October 13, 2021

RE: Benton County, Arkansas Suburban Sewer District No 1  
Villages of Cross Creek Apartments  
Permit # 4811-WR-5

**RESPONSE TO LETTER DATED AUGUST 4, 2021 PERMIT DEFICIENCIES**

Location of Treatment Plant and Drip Fields

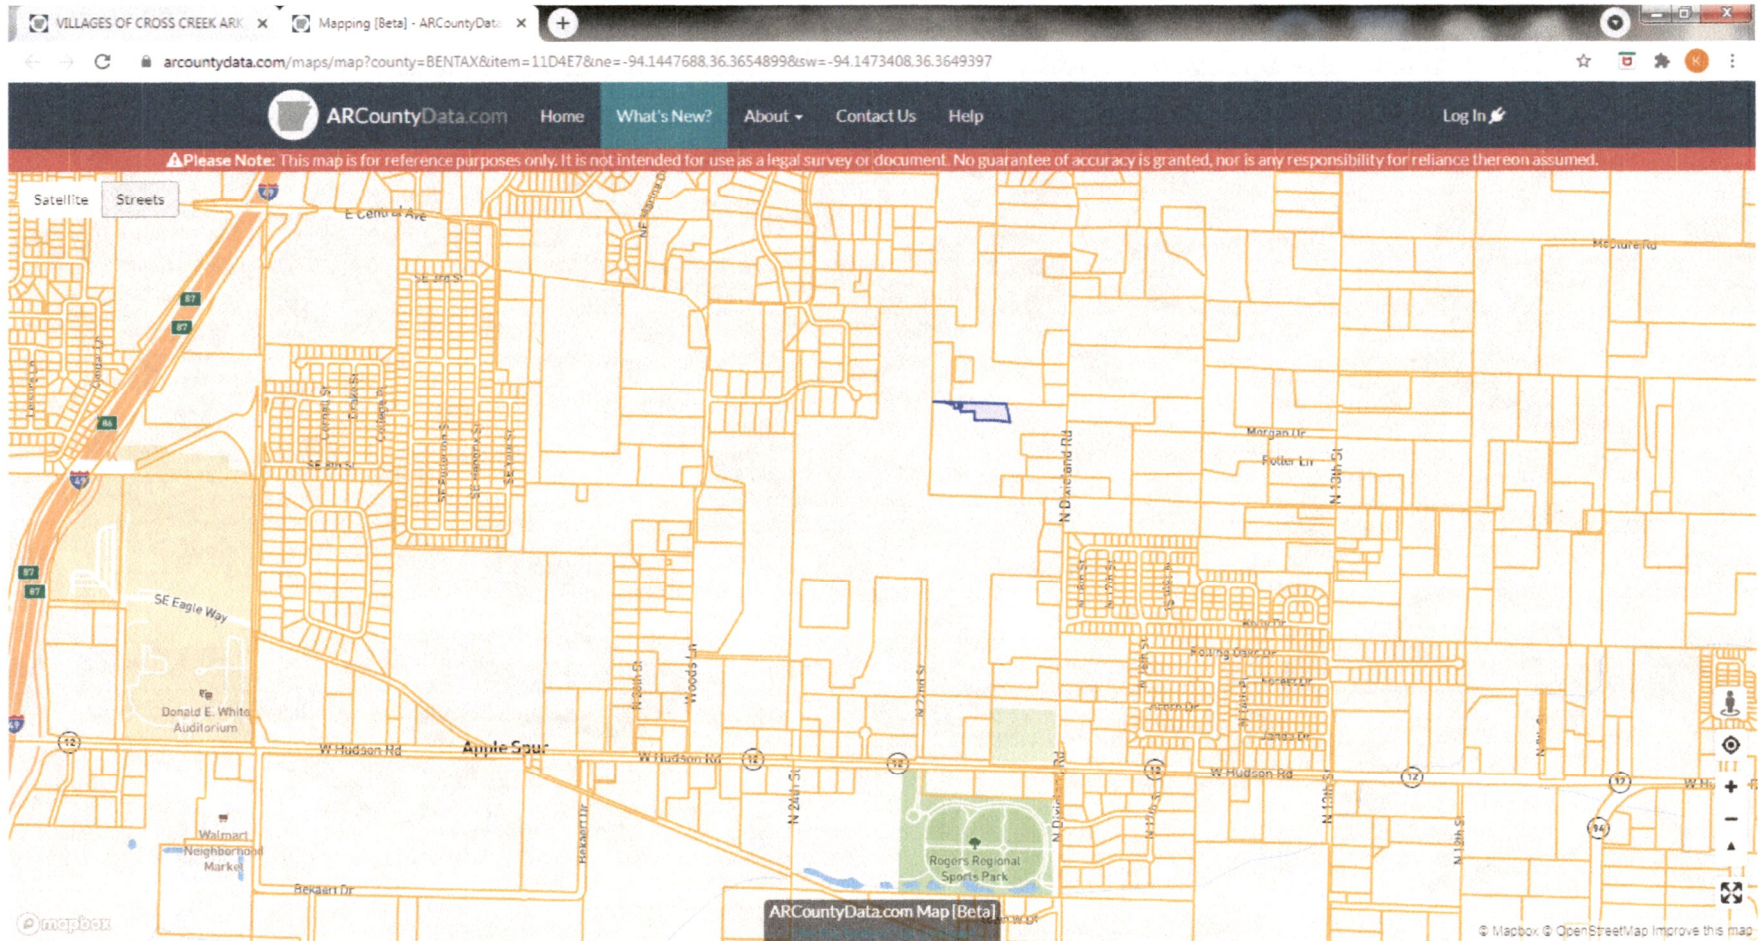
2. Updated maps showing the treatment system location, primary and reserve field is included with this response. As part of the CAP, additional reserve fields on land owned or planned to be utilized by a lease or land use contract by the permittee will be identified. This is necessary because a portion of the initial land set aside as reserve is not suitable for reserve drip fields due their condition and location in the apartment complex. The original consulting engineer for the initial permit did not provide detailed drawings of the drip lines. The installer cannot provide a layout of the drip irrigation lines. We have exhausted all efforts to obtain documentation showing the location of all soil pits. The soil classifier who had the pits dug and analyzed no longer has the records and cannot provide this information to us. I was able to get a very rudimentary layout of the pit locations in the south drip fields from the ADH. These pits coincide with Appendix C Soils Investigation Report which is identified as the South portion of the drip dispersal fields. Soil Investigation Report #2 does have a map identifying the pit location numbers 18-29 in zones 1 – 6 of the active drip fields. All of this information is included with this response.

**Drip Field Pump Sizing**

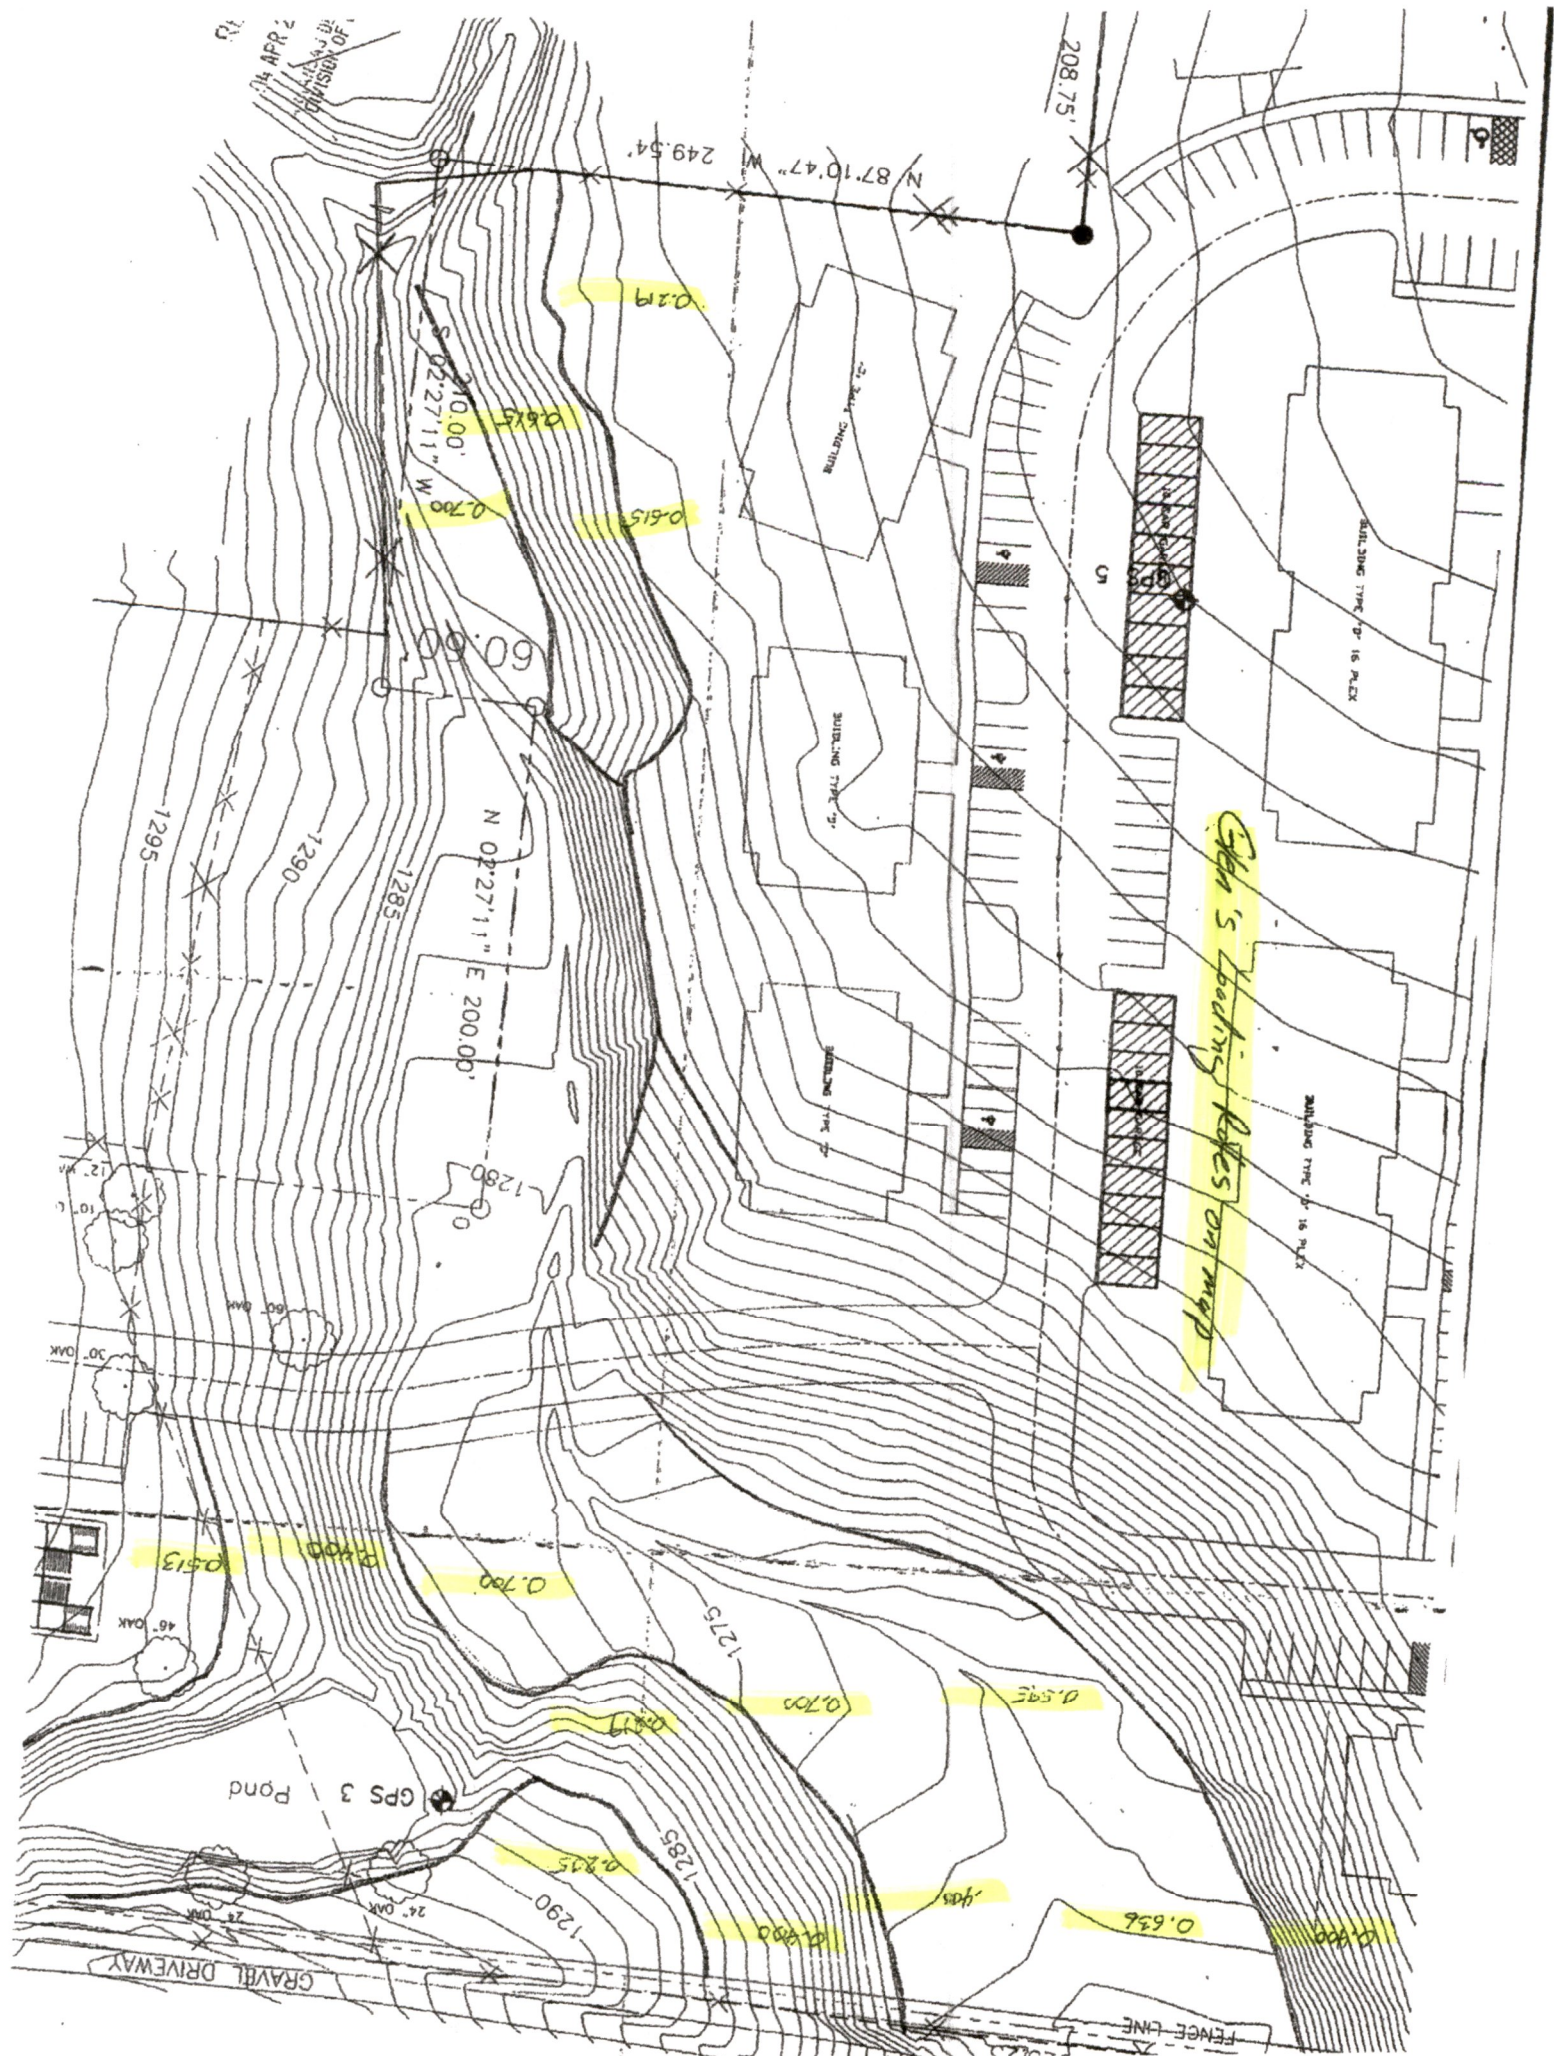
6. The Geoflow sizing charts and calculations originally included with the technical specifications on the initial permit are included with this response.
